Urgent Field Safety Notice

Manufacturer's reference: SB_RDC_2019_05

Important information on the Accu-Chek® Solo micropump system related to a new method to insert the pump into the pump holder in order to avoid insulin leakage

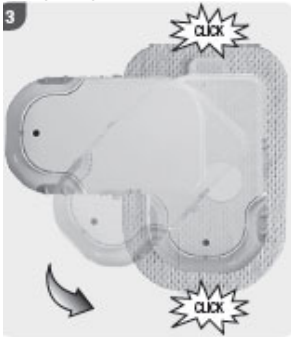
1 Place the reservoir needle on the grey cannula head of the pump holder.

2 Place the reservoir needle of the micropump on the grey cannula head of the pump holder.

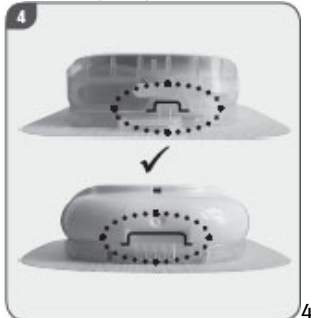
3 Turn the micropump carefully into place. After a quarter turn, the micropump clicks into the front hooks on the pump holder.

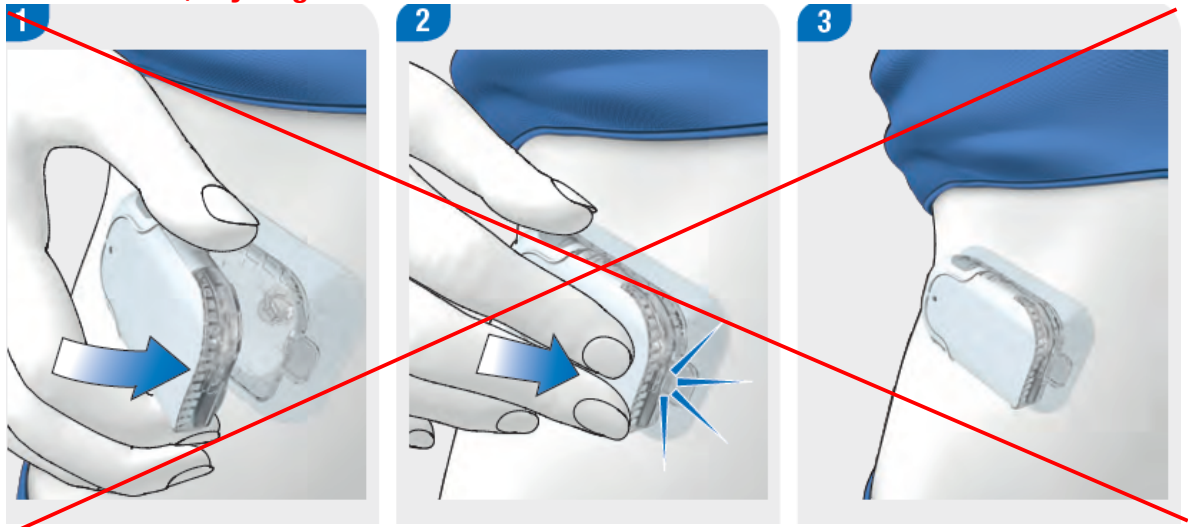
4 Make sure the micropump engages properly with the front and back hooks on the pump holder. If not, press onto the pump shield until it clicks into the pump holder.

Don't apply too much force when attaching the micropump, because the septum between the pump and the cannula assembly may become damaged and, as a consequence, insulin leakage can occur. This may lead to an insufficient supply of insulin.
